PLANNING COMMISSION MEETING

PLANNING COMMISSION
FINDINGS OF FACT
RVW25-000028
TYPE III DECISION PROCESS

REQUEST: To approve an 84-room extended stay hotel and associated maintenance shed.

1 FRONT ELEVATION
1/8" = 1'-0"

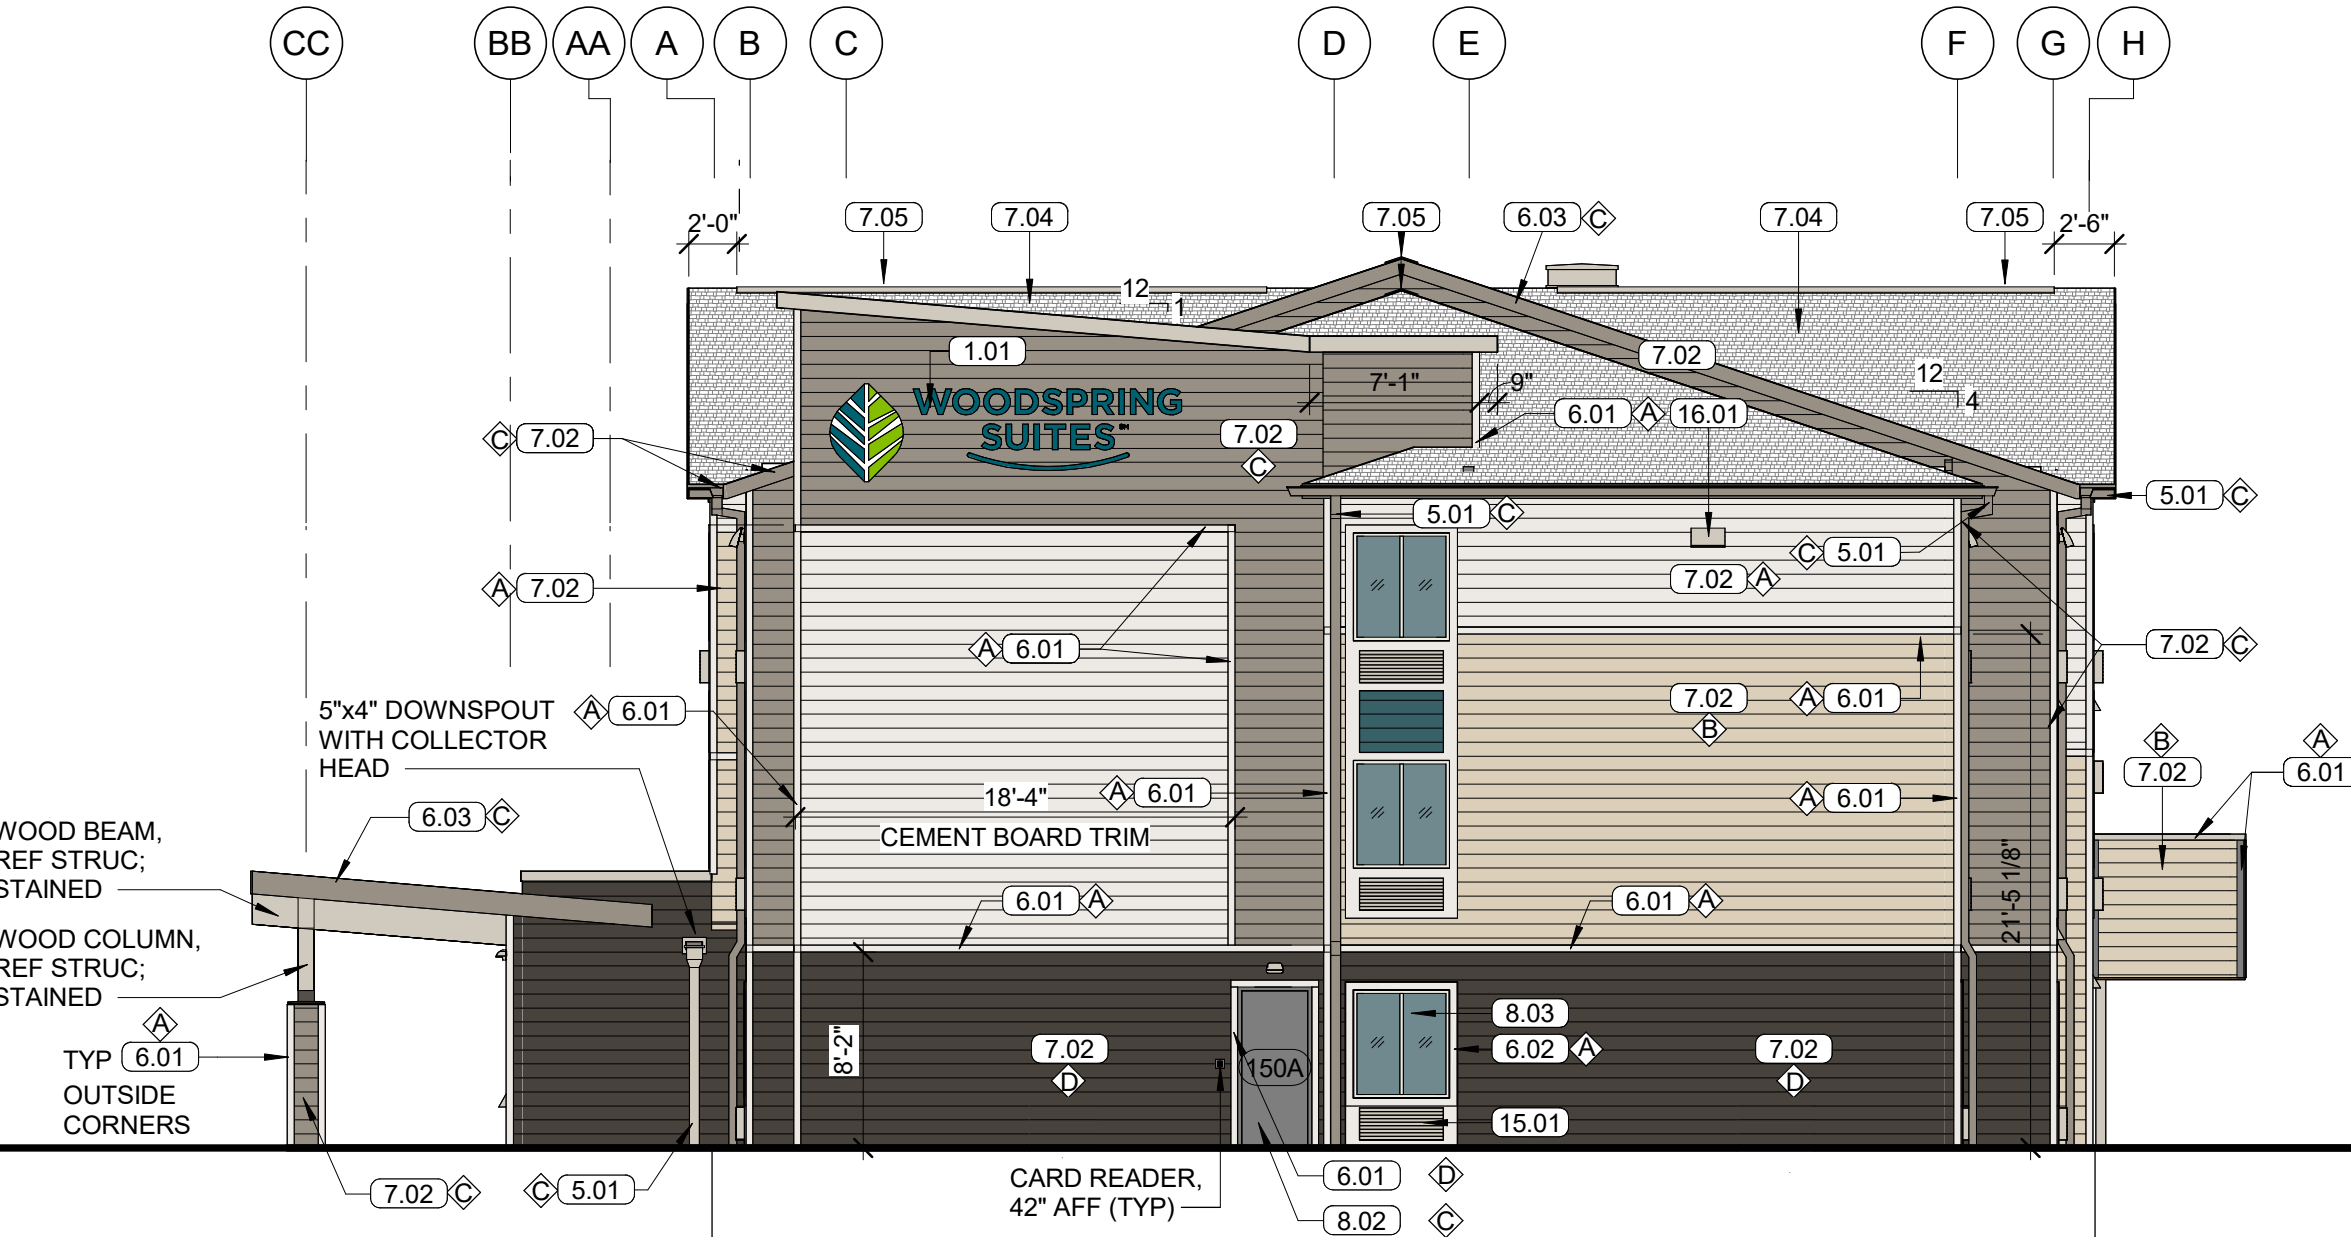
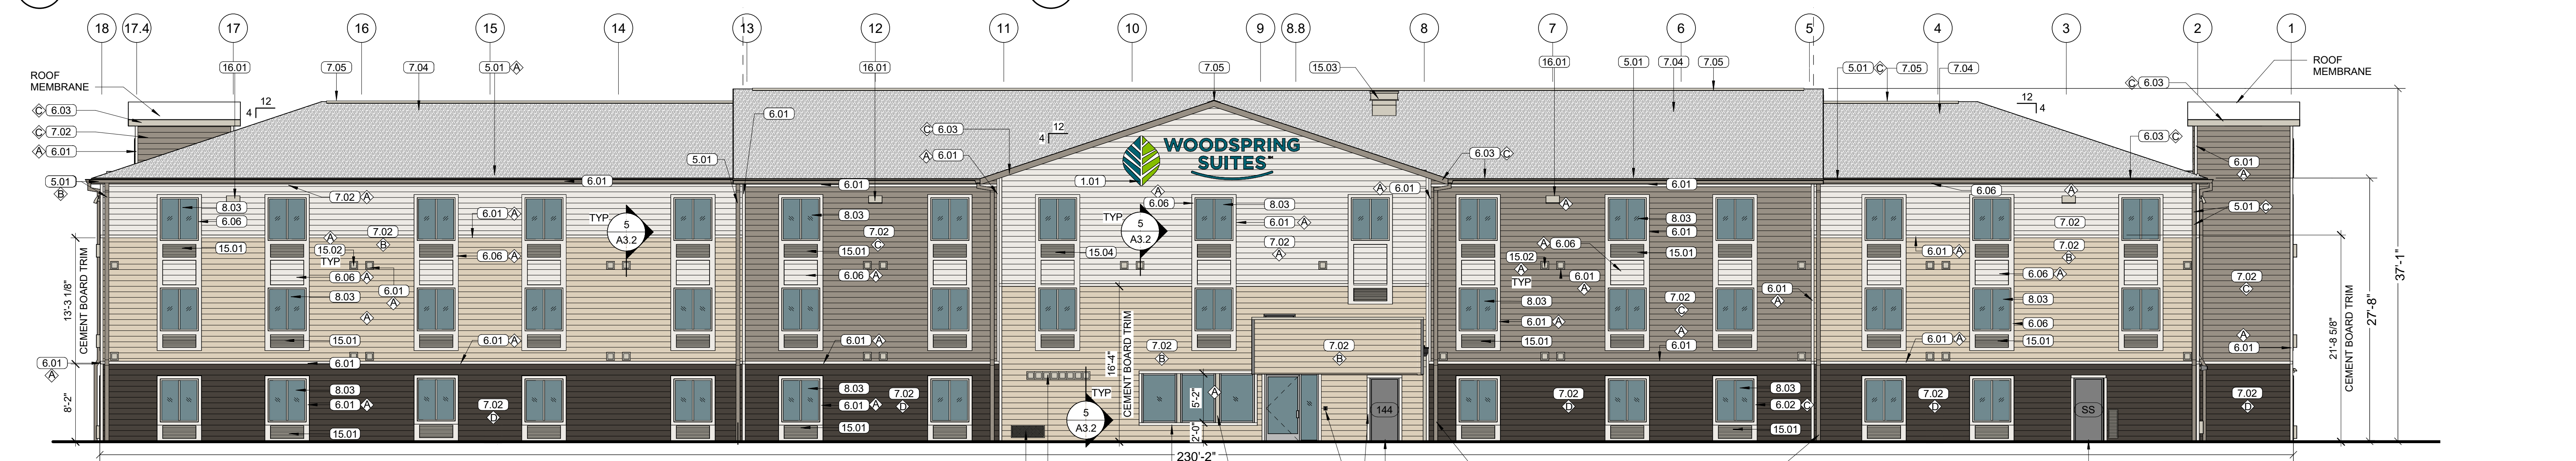
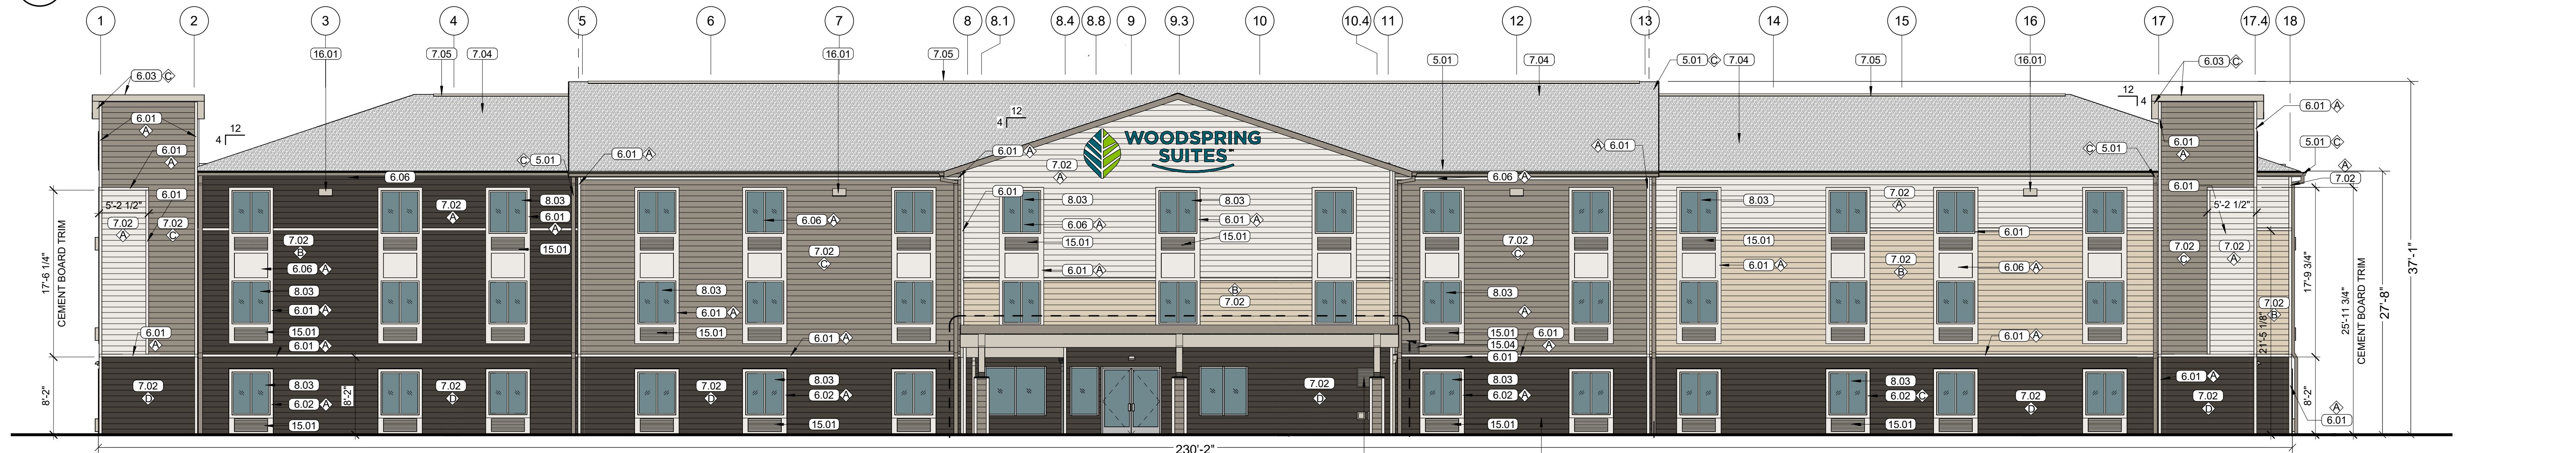
The submitted architectural drawings indicate a building height of 37' 1" which exceeds the height limit for the Tourist Commercial subdistrict by 2' 1". The applicant needs to either shorten the proposed building or request a Variance. This is listed as a condition of approval.

- 4. To meet the height requirement standards, the building will need to either be shortened or a variance will need to be obtained.
- 5. The applicant shall submit plans for and obtain proper permits for signs, structures, and landscaping showing all vision clearance areas to be free and clear.
